HATFIELD BOROUGH PLANNING COMMISSION

JULY 11, 2022

**3. 28 N. MARKET STREET: ESTATE OF JACK
ZAMPIRRI MINOR SUBDIVISION
PRESENTATION**

As requested, Bursich Associates, Inc. has reviewed a Minor Subdivision plan submission prepared for 28 N. Market Street. The submission consisted of the following information prepared by Metz Engineers:

1"=20'
PLAN SHEET NUMBER
1 of 3

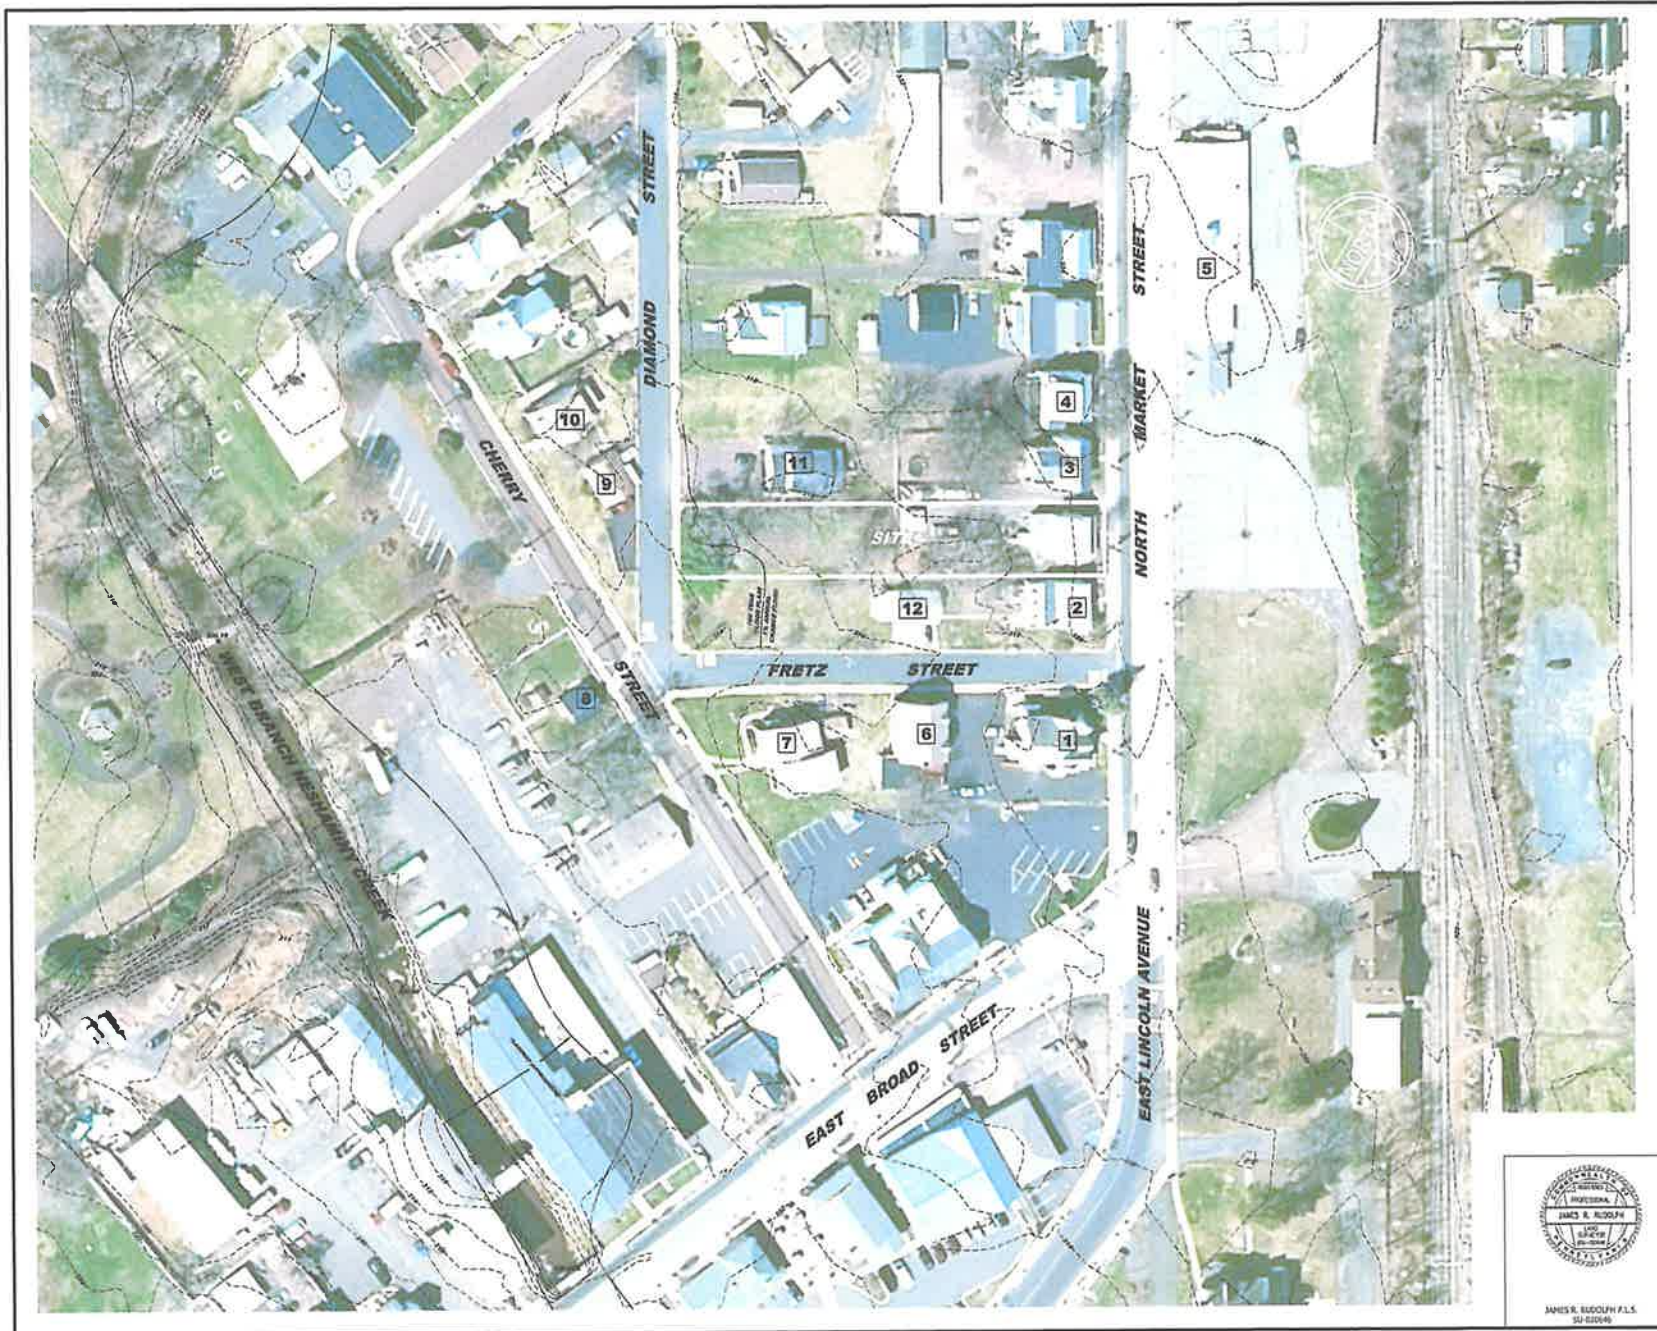
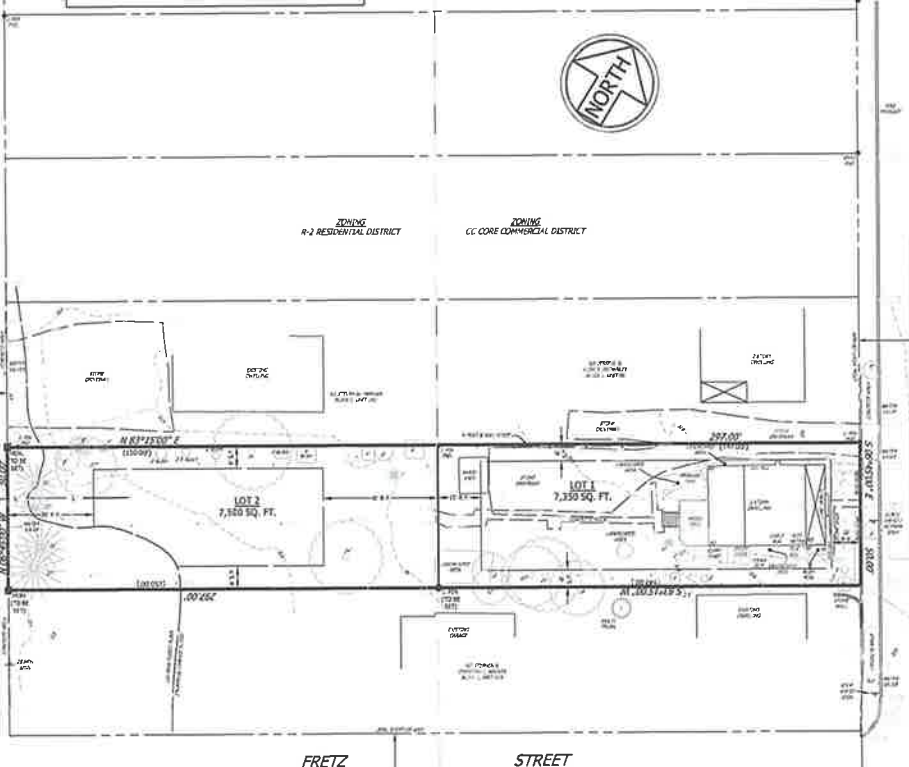
The following waiver request was noted on sheet 1 of 3 of the submitted plan:

1. §22-310.1.B.(1).(c) – The proposed lot line must include metes and bounds.
2. §22-426 – The Applicant shall present evidence that water to Lot 2 can be supplied by a certified public utility. Correspondence shall be provided from the water authority indicating they can supply water to the property. The location of the nearest water main shall also be illustrated on the plans.
3. §22-427 – The Applicant shall present evidence that sewer service for Lot 2 can be supplied by a certified public utility.

1. The plan shall clarify if the portions of the existing concrete walk and landscaped area that encroach onto proposed Lot 2 will be removed.
2. Access to the existing property (proposed Lot 1) requires traversing a common driveway through the adjoining Brownlee property. We suggest a common driveway access agreement be recorded to establish the rights and responsibilities of the property owners.
3. Legal descriptions shall be submitted for the two lots created by the subdivision.
